SERVICE No. 177 BULLETIN

Piper Aircraft Corporation

SUBJECT: Fuel Cell Filling Instructions

MODELS AFFECTED: PA-24 and PA-24 "250"
Serial Numbers 24-1 to 24-1264 inclusive

FUEL PLACARD DETAIL (ON PA-24 ONLY)

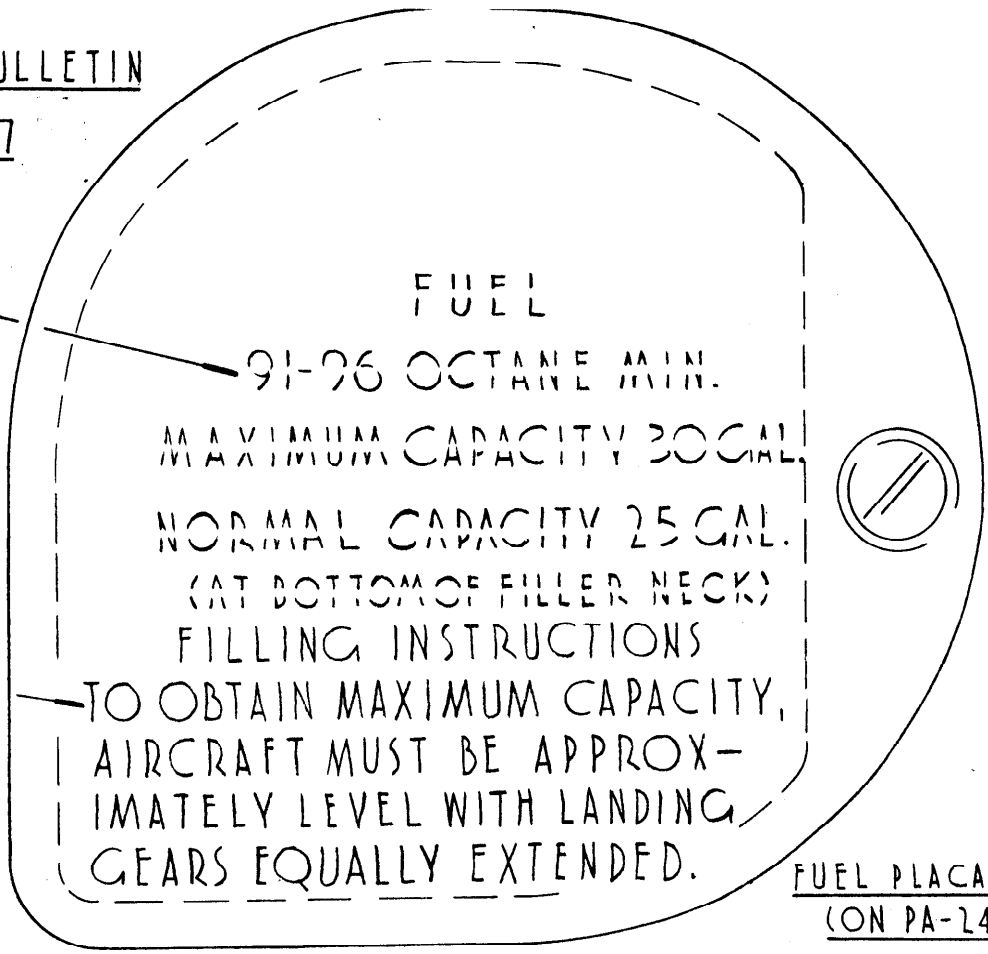
The above mentioned airplanes shall have a Fuel Cell Filling Instructions placard added to the left and right fuel cell filler neck cover plate during the next 100 hour periodic inspection. These instructions indicate the proper method of obtaining the maximum fuel tank capacity of thirty (30) gallons per tank.

Apply this placard per sketches shown on the reverse side of this bulletin by bending a corner of the placard sharply and peeling the film from the backing. Ascertain that the metal surface is clean and dry before placing the placard in the desired position and smoothing out with a squeegee.

PLACARD 21994-00
